# Urban Renewal Plan Design Review

## THE SONO COLLECTION PROJECT

Prepared for the Norwalk Redevelopment Agency  
Prepared by The Cecil Group/Harriman with Tighe & Bond  
May 20, 2016

**Peer Review Report**

1 PLAZA A SECTION A-A1  
1/2\"/>

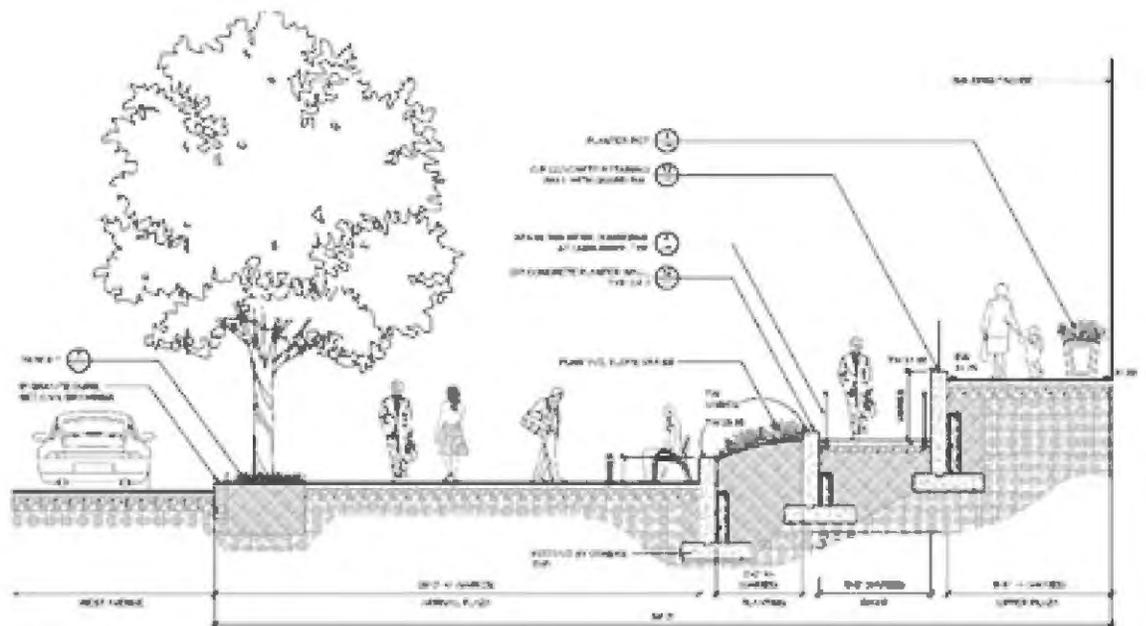
Plans provided by the proponent indicate the Project has incorporated three open space plazas along the Project's West Avenue side. Each of these plazas are connected by a row of street trees and varying landscape elements to the Project's Pine Street side. The Project incorporates landscaping on the northern side that provide a buffer to Interstate 95 and connect to the existing landscaping alongside the highway. The Project also provides pedestrian connections to nearby Oyster Shell Park.

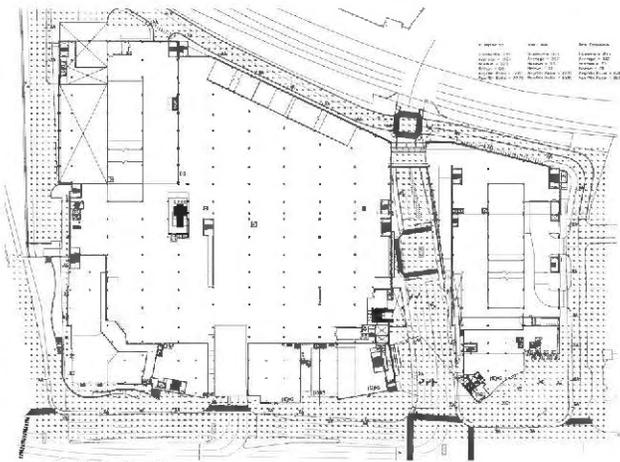
The top parking level will have LED fixtures using 18-foot standard height supports. A review of the photometric plan indicates typical illumination levels that are about 4 footcandles (Fc). The uniformity ratios range up to a maximum/minimum of about 18. The photometrics indicate the use of fixtures with high-cut off characteristics, with relative low illumination at the perimeter of the top parking deck.

The average illumination levels and maximum uniformity ratio on the sidewalks and streets are as follows: North Water Street (10 Fc, 27 max/min); West Avenue (2 Fc, 65 max/min); Pine Street Extension (3 Fc, 15 max/min). The illumination levels along the North and South Service Drives and the north side loading dock drive appear to be consistent with safe operational levels ranging from about 1 Fc to 5 Fc.

These lighting levels are consistent with intensities provided for safe pedestrian areas, streets and intersections in urban areas. It should be noted that the lighting levels along North Water Street will provide high illuminance levels along a corridor where vehicles and pedestrian crossings occur. Also, the photometrics do not take into account the significant ambient lighting along the West Avenue sidewalk that will occur from the storefronts, building entrances and atria along this edge of the Project.
